Job ID: 2011-10-2410-ALTCOMM

has permission to Add a small 4th floor room & roof deck to existing 3rd flr apartment
provided that the person or persons, firm or corporation accepting this permit shall comply with all of the provisions of
the Statues of Maine and of the Ordinances of the City of Portland regulating the construction, maintenance and use of
the buildings and structures, and of the application on file in the department.

Conditions of Approval:

Arnold Addition

3rd FLOOR PLAN

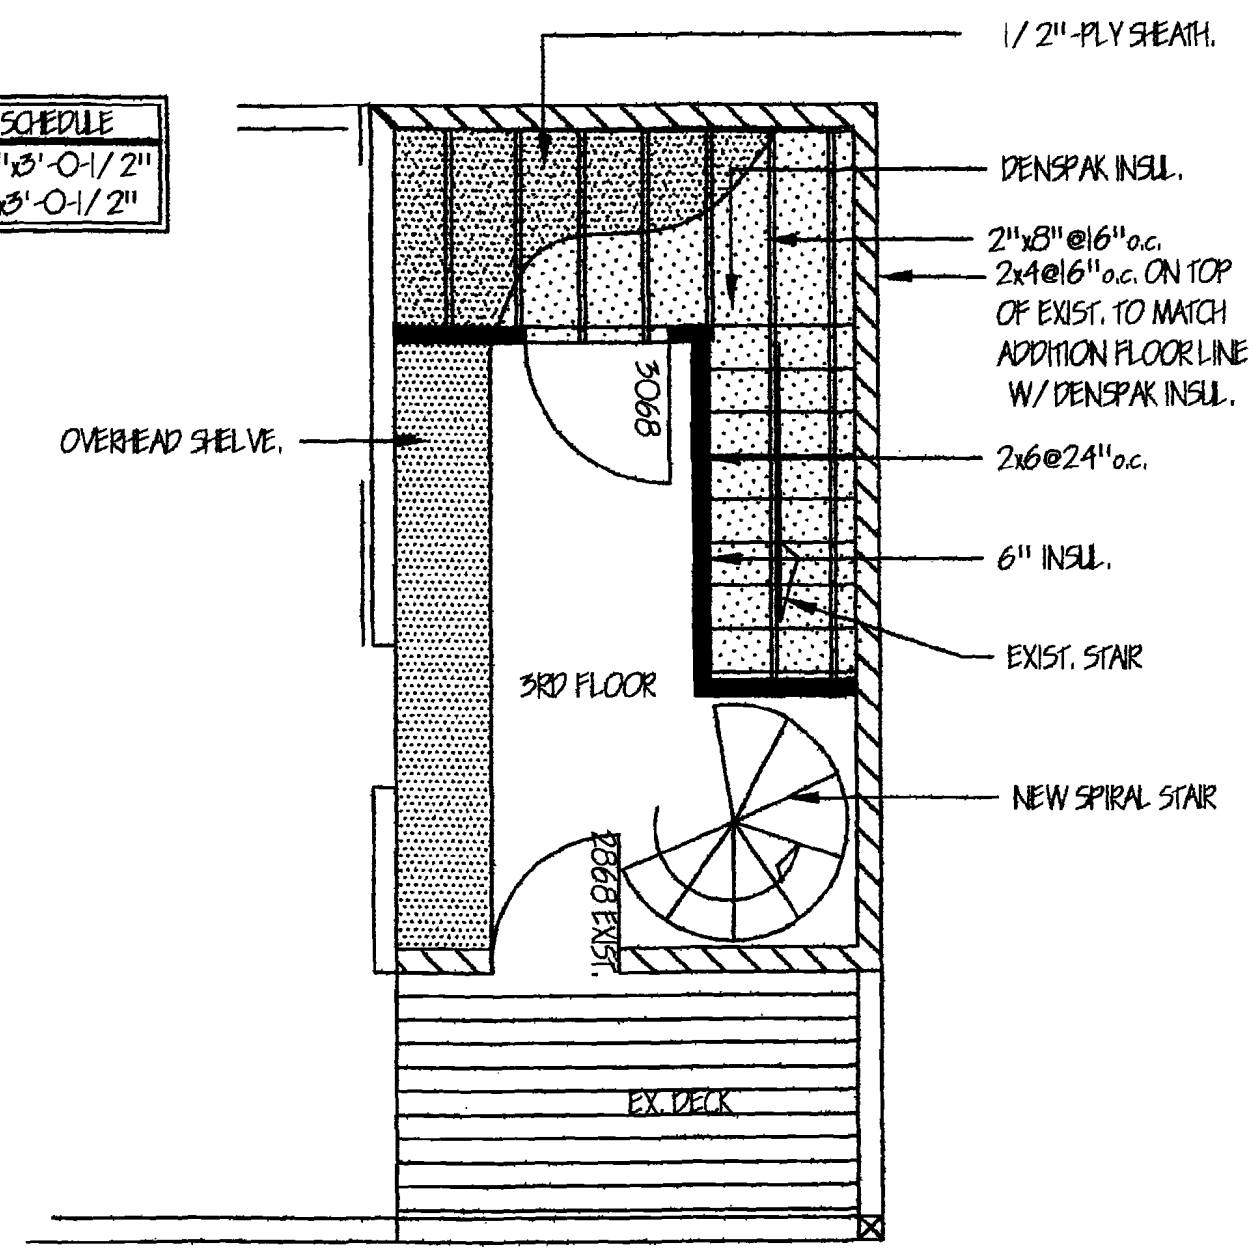
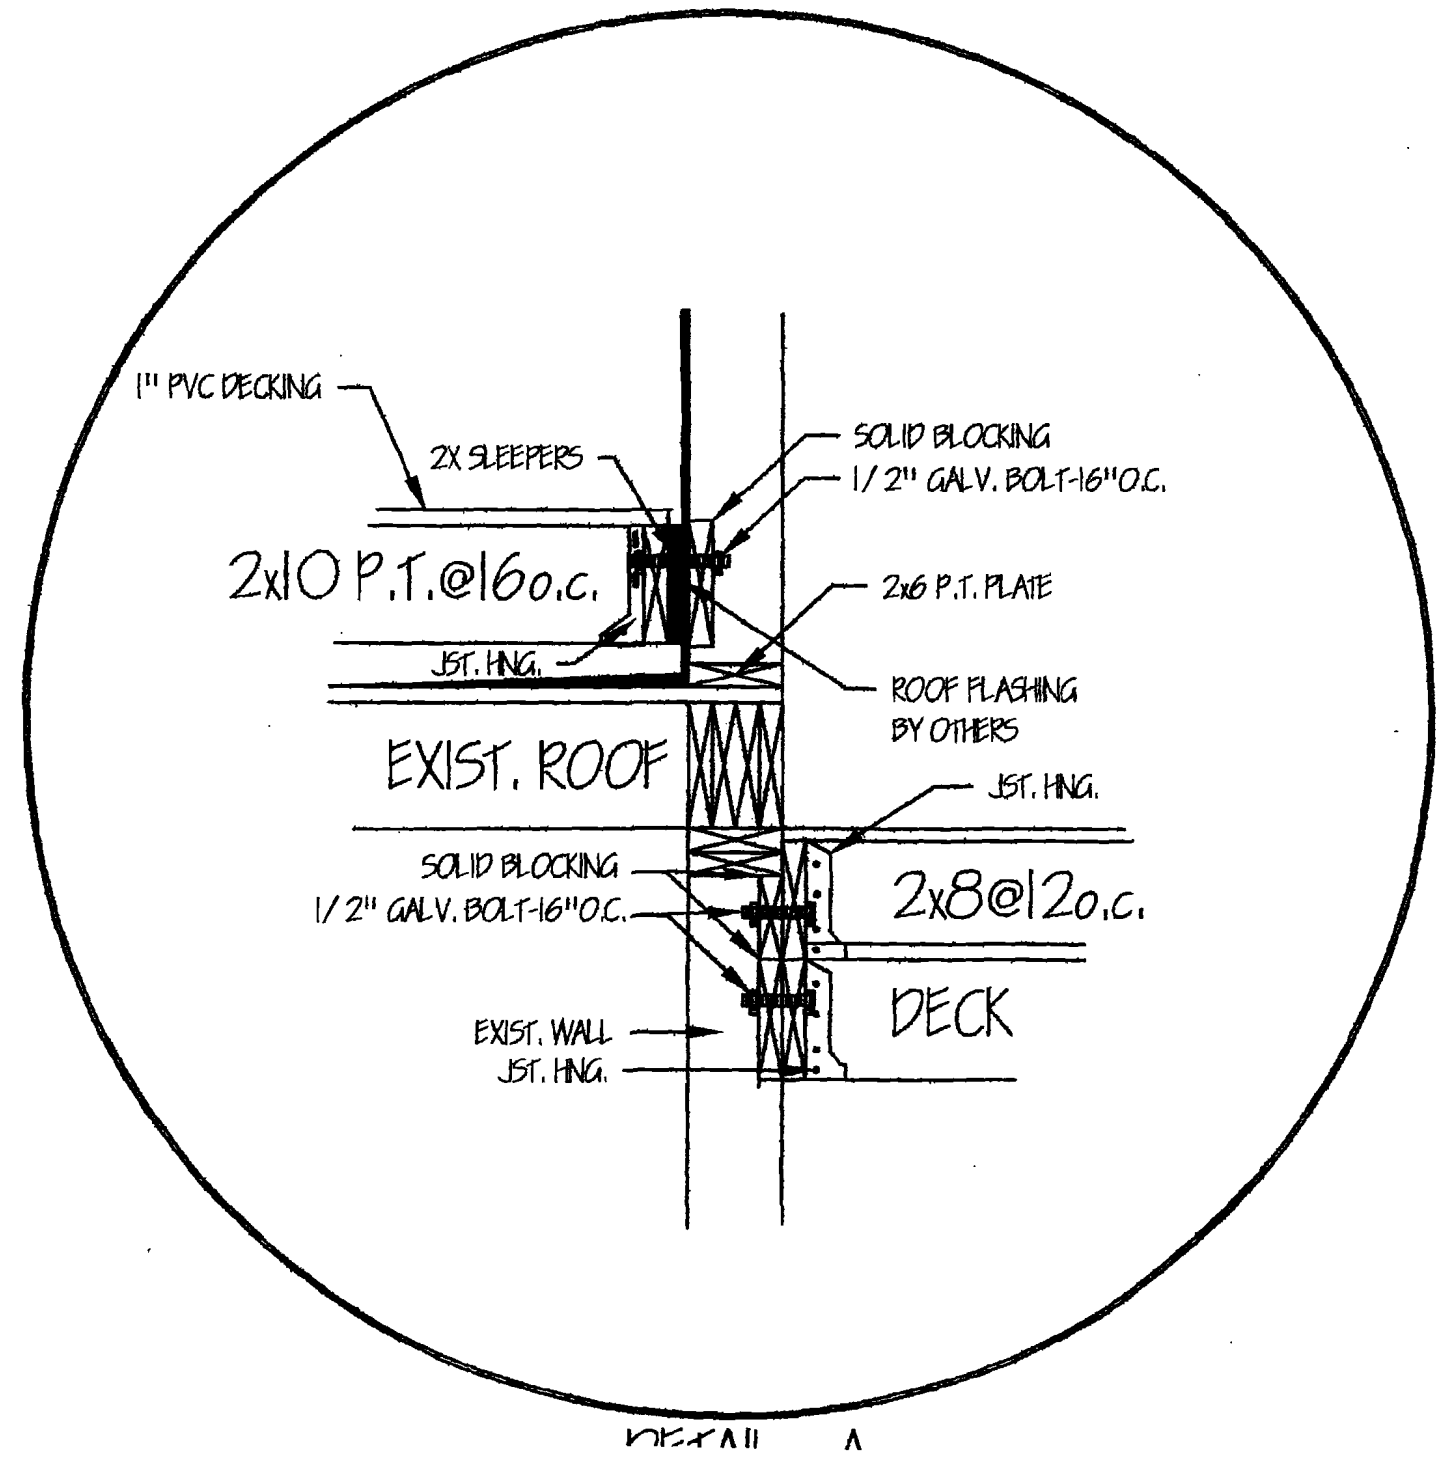
Thanks Ted,
Do you happen to have a floor plan of the 3rd floor unit, it would be helpful to see the context of where this is in the building and the two means of egress stairs. I can issue the permit, but would like this for the record.
This will be mailed tomorrow.
Thanks
Jeanie

Thanks for your work on this project. Here is a .jpeg of the third floor floor plan, and on the right is the floor plan with the proposed deck and room superimposed and highlighted. If you need a better document, let me know.
